Re: **Initial Submission Review** – Green Valley Ranch East Site Plan No 6 Amdt – Site Plan Amendment and Replat
Application Number: **DA-1662-33**
Case Numbers: 2023-3055-00; 2021-4012-01

The following are written responses to the City comments dated November 17, 2023 for your review. We have also included responses on the redlines PDF for your review.

GREEN VALLEY RANCH EAST SITE PLAN #6

SHEET 18 OF 36

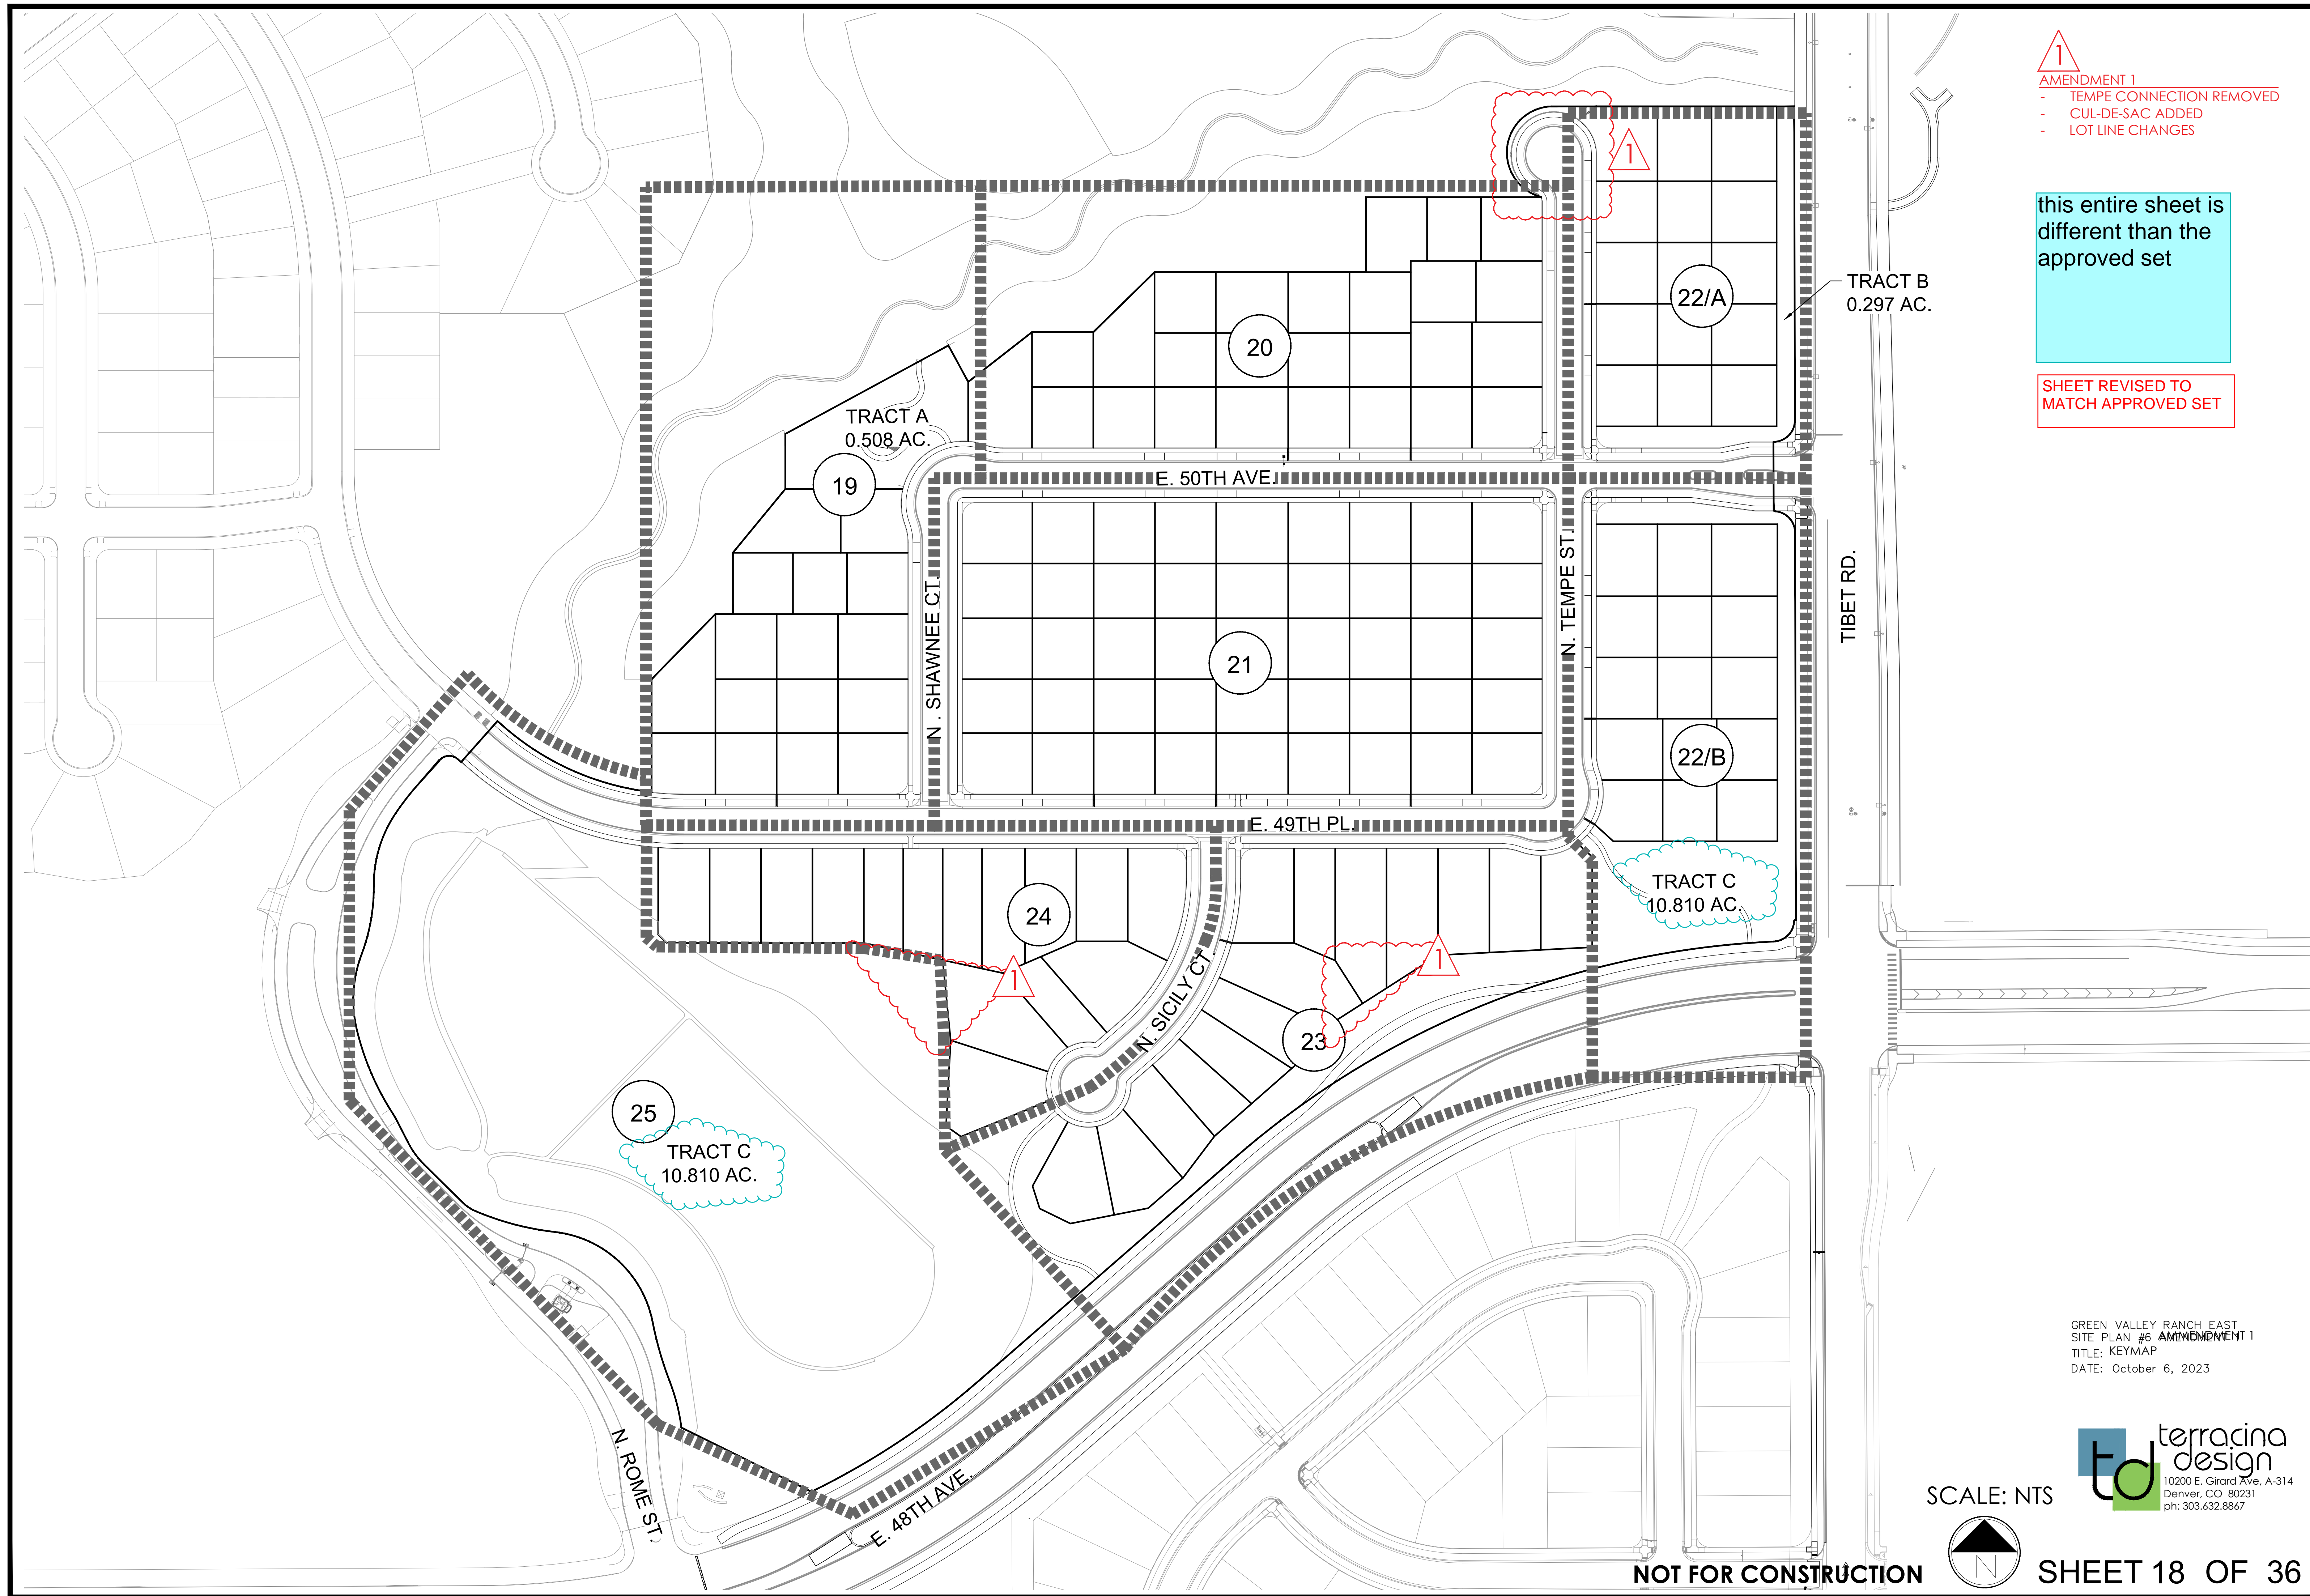
3A. Sheet 18 is entirely different than the approved sheet. Is there a reason? Cloud revisions, especially the tract areas. **RESPONSE: Sheet revised to better match what was already approved. Revised areas now shown better with revision clouds.**

this entire sheet is
different than the
approved set

SHEET REVISED TO
MATCH APPROVED SET

GREEN VALLEY RANCH EAST
SITE PLAN #6 AMENDMENT 1
TITLE:
DATE: October 6, 2023
LANDSCAPE PLAN

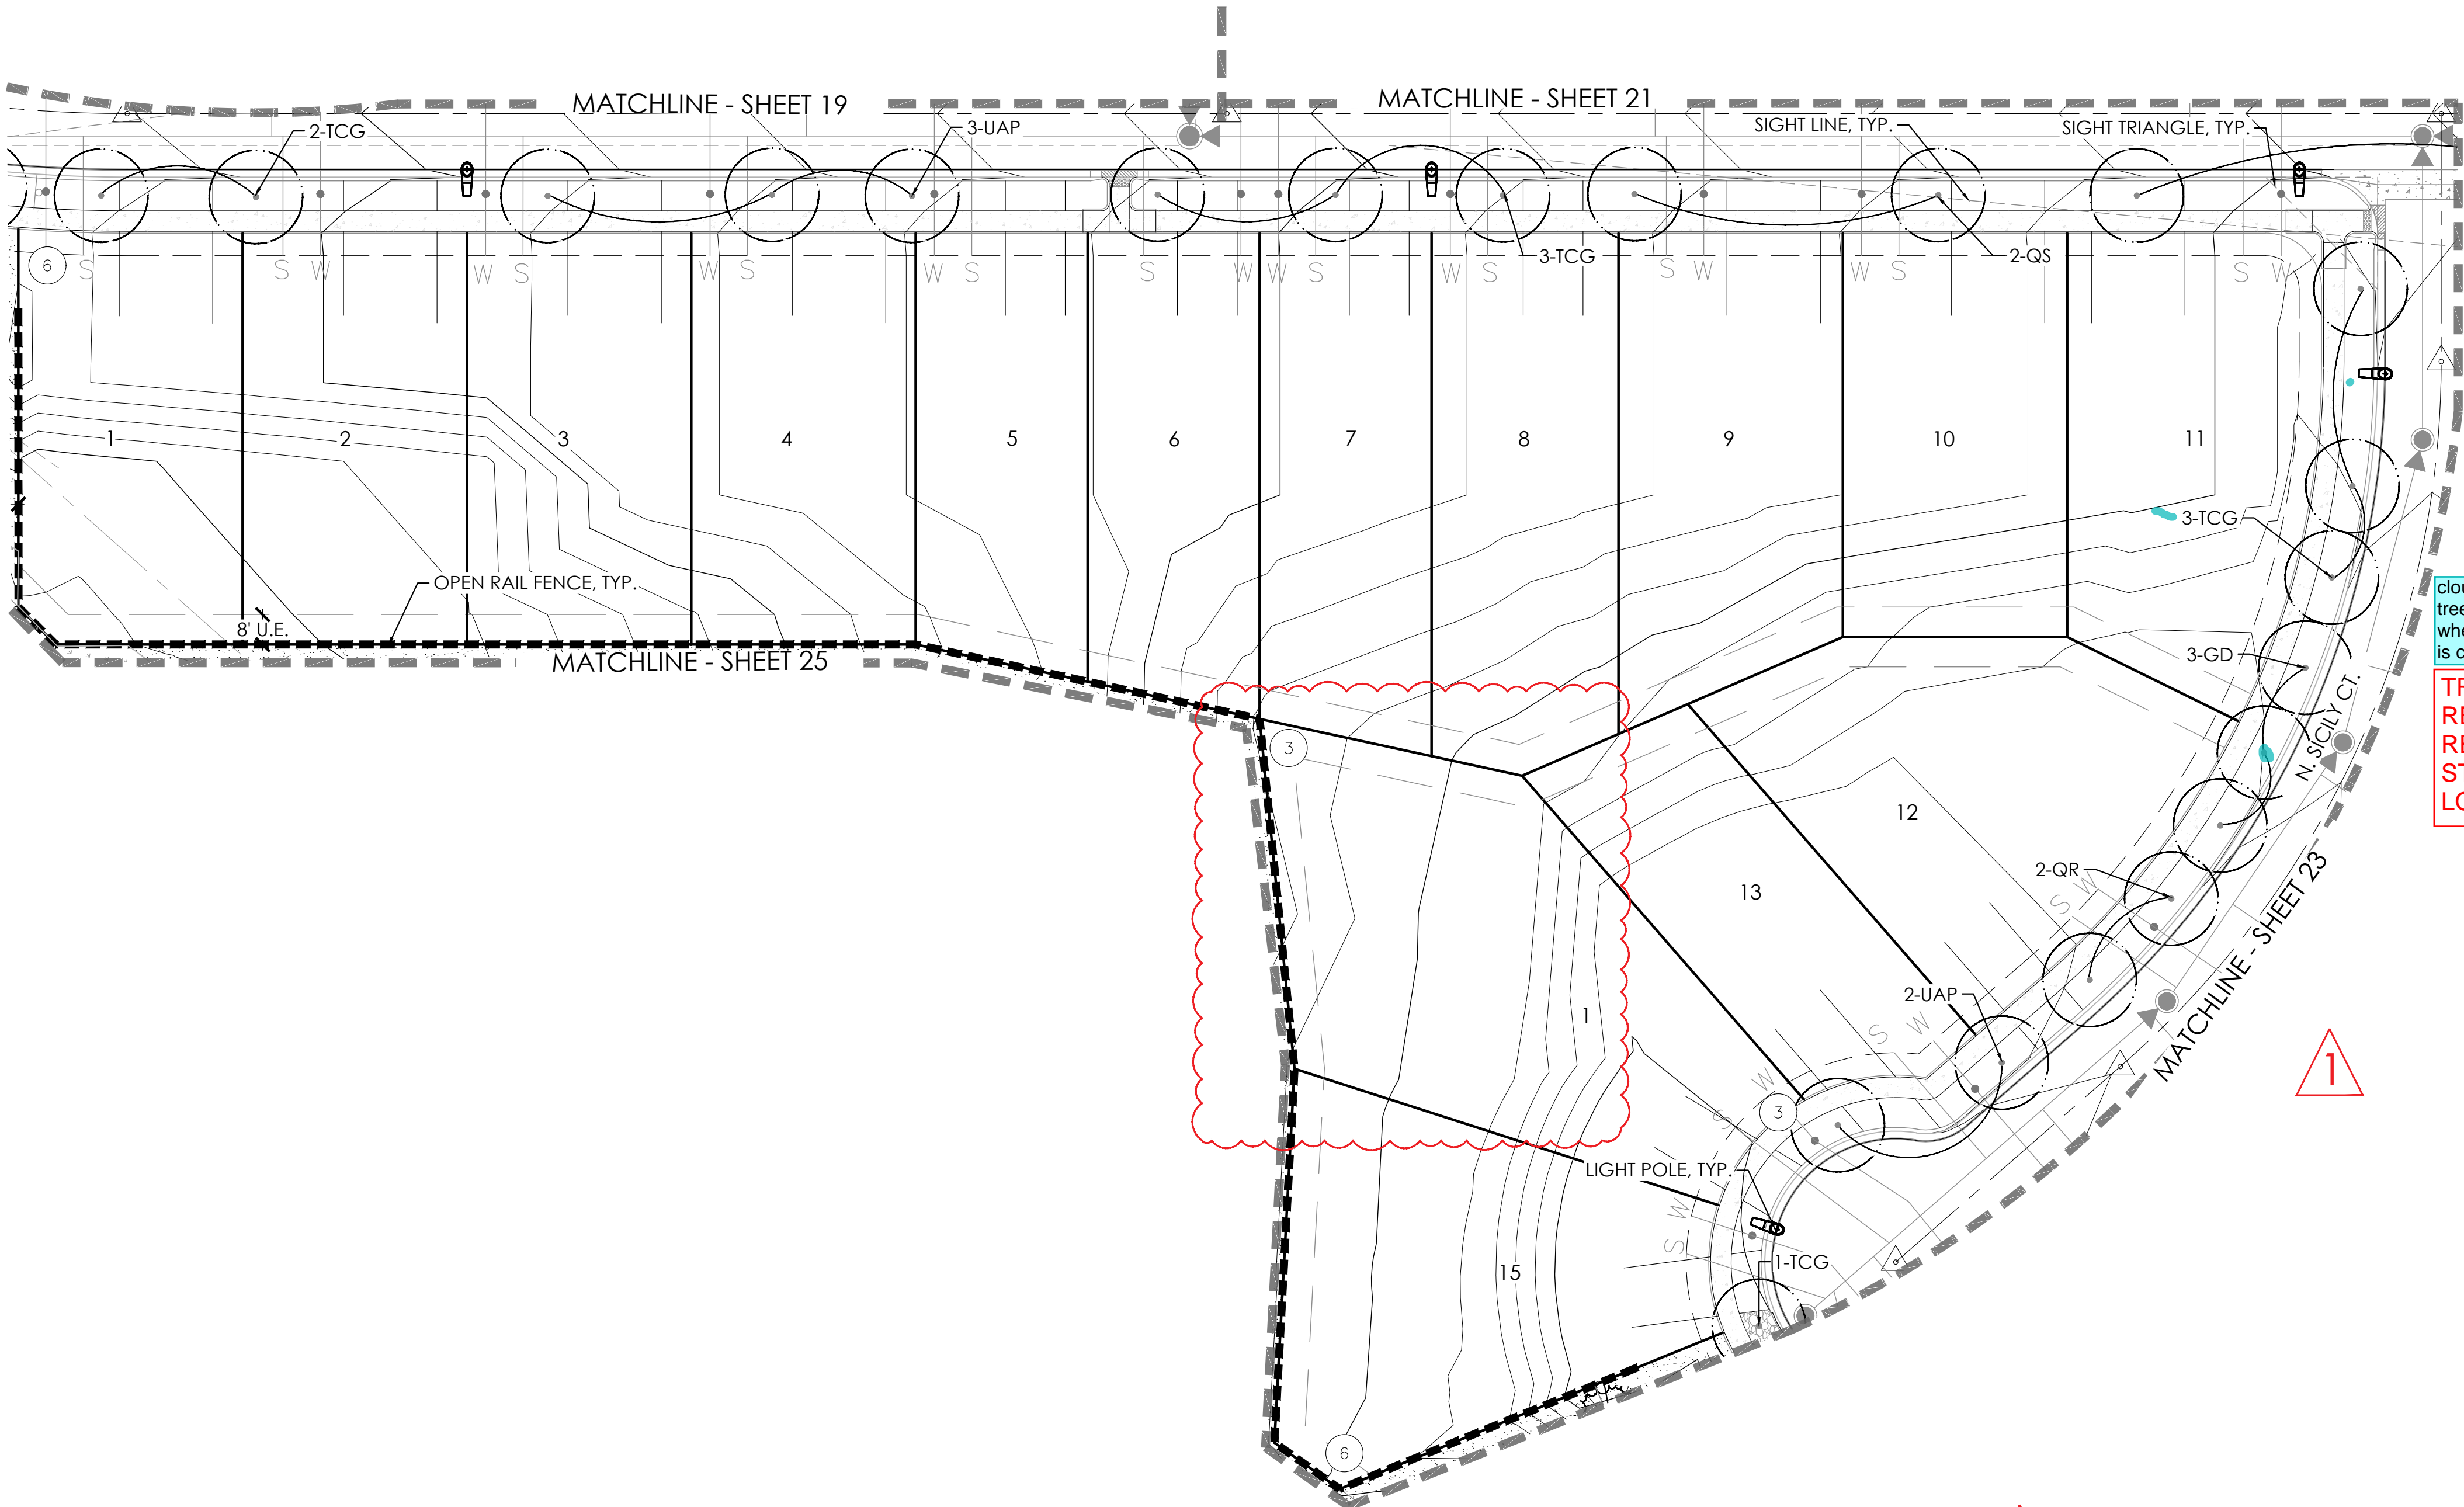
update to
match site plan
sheets.
Cloud all
revised areas

did these areas
change? Cobble on
approved plans

EXISTING MAINTENANCE
ACCESS
add symbol

TREE TOTALS
REMAINED THE SAME.
REVISED AROUND NEW
STREET LIGHT
LOCATIONS
